APPLICATION NO.	FILING DATE	FIRST NAMED INVENTOR	ATTORNEY DOCKET NO.	CONFIRMATION NO.
10/735,440	12/12/2003	Fabian Kollmann	3201-366 (D4700-00380)	2028

Office Action Summary

SN 10/735,440
Substitute Drawing

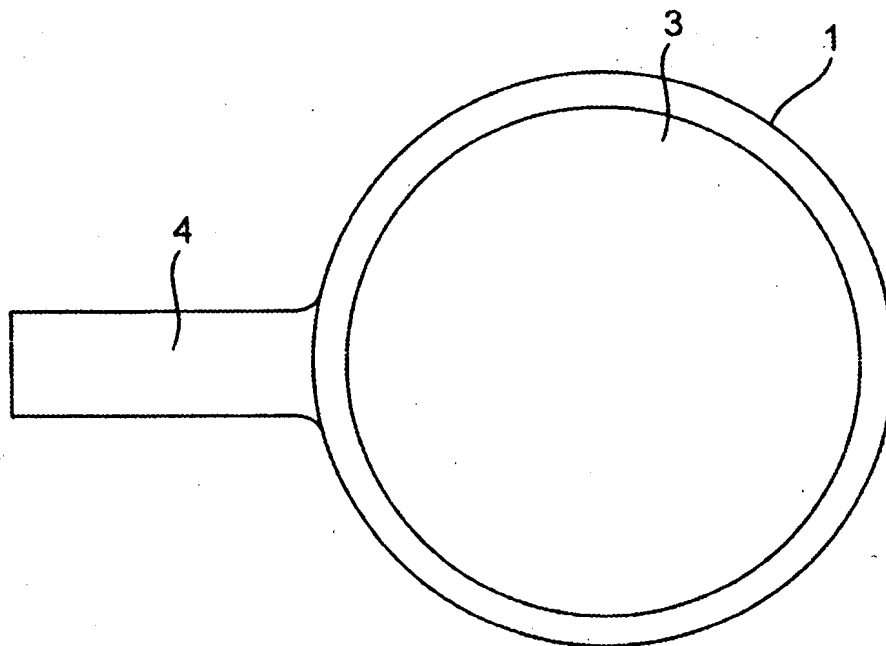
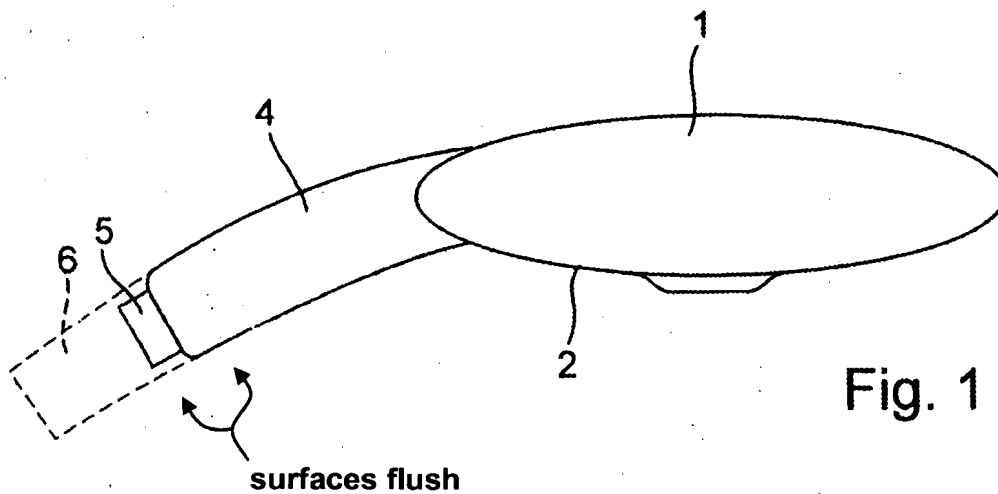
The proposed drawing correction filed on 9/28/07 is disapproved as the depiction of the union nut is inconsistent with that of the original drawings in that the double lines at the hose end are lacking, the fitting is of a different shape and the terminal end of the handle is rounded.

The drawings are objected to as being informal and for the use of a broken line showing of substance being claimed, i.e. under 37 C.F.R. 1.84(a)(4) broken lines are reserved for "alternate views". Corrected drawing sheets in compliance with 37 CFR 1.121(d) are required in reply to the Office action to avoid abandonment of the application. Any amended replacement drawing sheet should include all of the figures appearing on the immediate prior version of the sheet, even if only one figure is being

not approved
11/9/07 CEP
